SUBJECT: 25-040 Loaf Land Subdivision - Comment Response

Thank you for your continued review of the Subdivision Application Permit (SP 4103) for Loaf Land Subdivision in Coplin Plt.. The team recently received the additional review comments from LUPC in regard to this application, dated August 27, 2026. These comments can be seen below in *italic*, followed by Main-Land's response in regular typeset. Updated or amended exhibits have been provided as attachments.

POND DRAINAGE PLAN

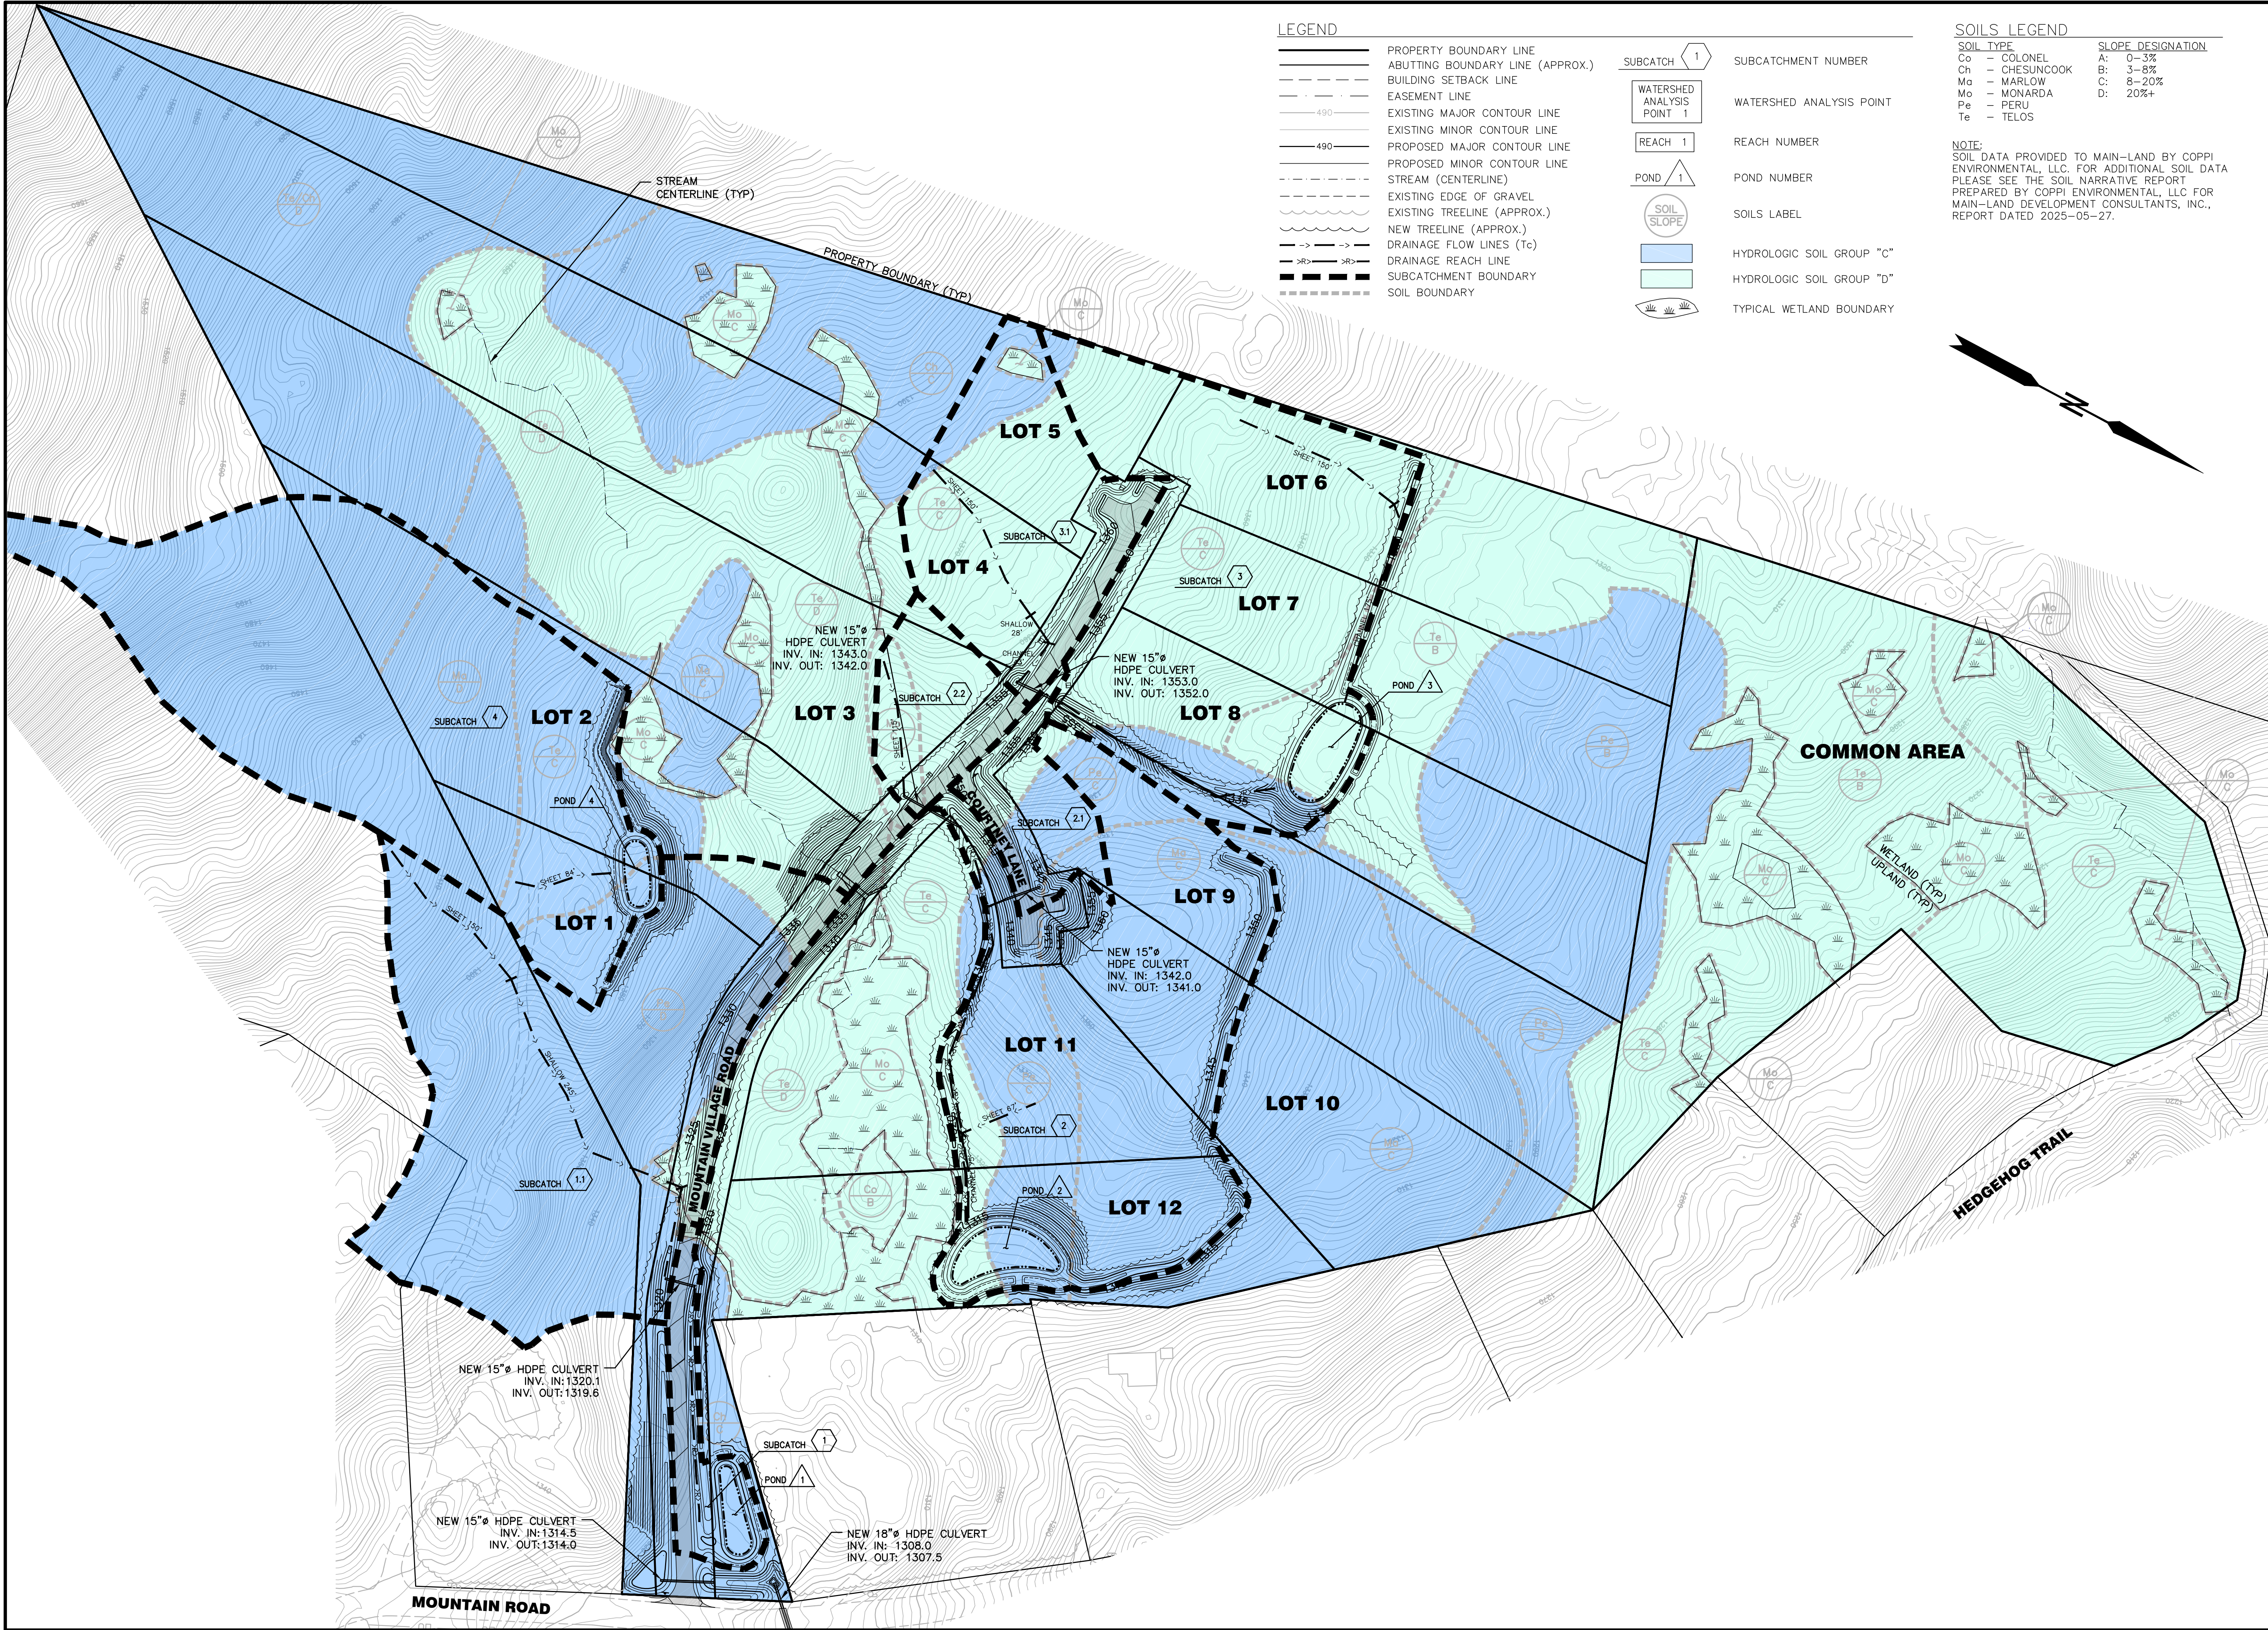
- *Site Plans (Ex. 10)*
 - *Provide a drainage plan that shows the soil types and boundaries to facilitate evaluation of the phosphorus export coefficients used (see Sebago Technics review comment III.2).*
 - *Sebago Response: Worksheet 2 lists 4 Lots for FP2 and 6 lots for FP3 whereas the narrative lists 5 lots for both Filter Ponds. Additionally, the 2 August 21, 2026 Loaf Land Subdivision – Coplin Plantation, ME LUPC Phosphorus Review drainage plan does not show the soil types and boundaries, so it is difficult to evaluate whether the correct export coefficients are being used for the lots. Below you can see for FP2 Lots HSG-C 4 lots (6th row), and on the Line FP4- Lots HGS C , 2 lots are listed (last row). These differ from the narrative and should be clarified in the report.*

- *Phosphorus Control (Ex. 33)*
 - *Clarify the number of lots served by Filter Ponds 2 and 3. The narrative states that Filter Ponds 2 and 3 serve five lots each. Sheet #5 (Maine DEP Phosphorus Worksheet #2) shows Filter Pond 2 serving four lots and Filter Pond 3 serving 6 lots (see Sebago Technics review comment III.2).*
 - *Sebago Response: Worksheet 2 lists 4 Lots for FP2 and 6 lots for FP3 whereas the narrative lists 5 lots for both Filter Ponds. Additionally, the 2 August 21, 2026 Loaf Land Subdivision – Coplin Plantation, ME LUPC Phosphorus Review drainage plan does not show the soil types and boundaries, so it is difficult to evaluate whether the correct export coefficients are being used for the lots. Below you can see for FP2 Lots HSG-C 4*

Pond 2 & Pond 3 both treat 5 lots each, as listed in the narrative and depicted in the Drainage Plan. The ponds were sized approximately. Worksheet 2 has updated to reflect this. In addition, the soils have been overlaid onto the Drainage Plan with color for clarity.

Pond 2 & Pond 3 both treat 5 lots each, as listed in the narrative and depicted in the Drainage Plan. The ponds were sized approximately. Worksheet 2 has been updated to reflect this. In addition, the soils have been overlaid onto the Drainage Plan with color for clarity.

Image 1: Potential area that the project may be visual based on USGS Topographic Map

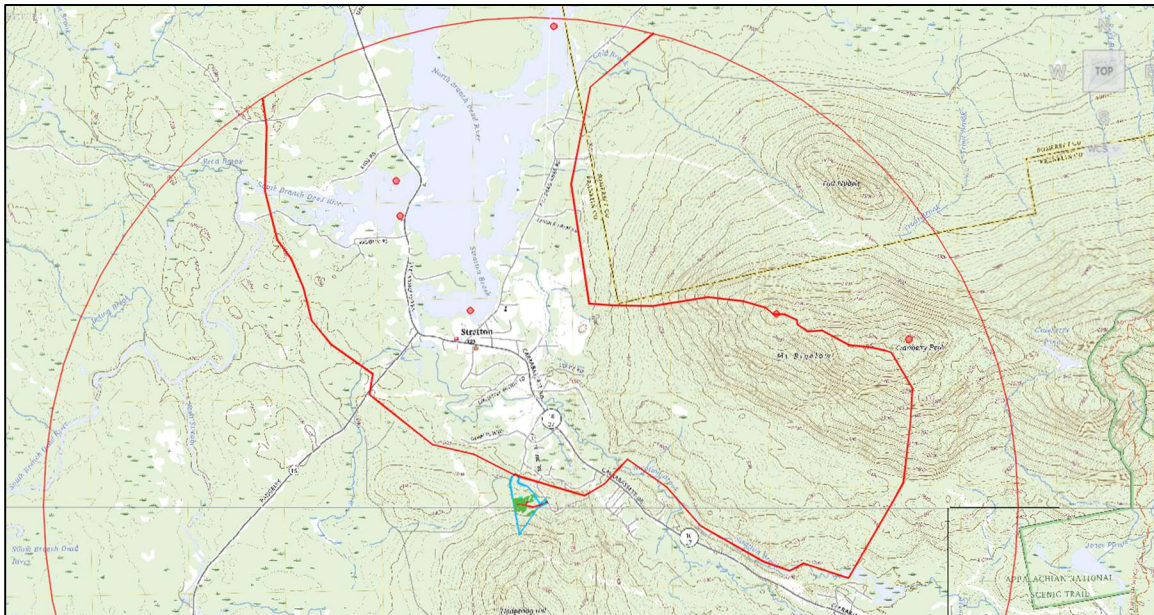
- *Harmonious Fit and Natural Character (Ex. 24)*
 - *Provide the methods for determining the viewshed depicted in Image 1 (p. 104).*

The narrative in Exhibit 24 has been updated to encompass this comment.
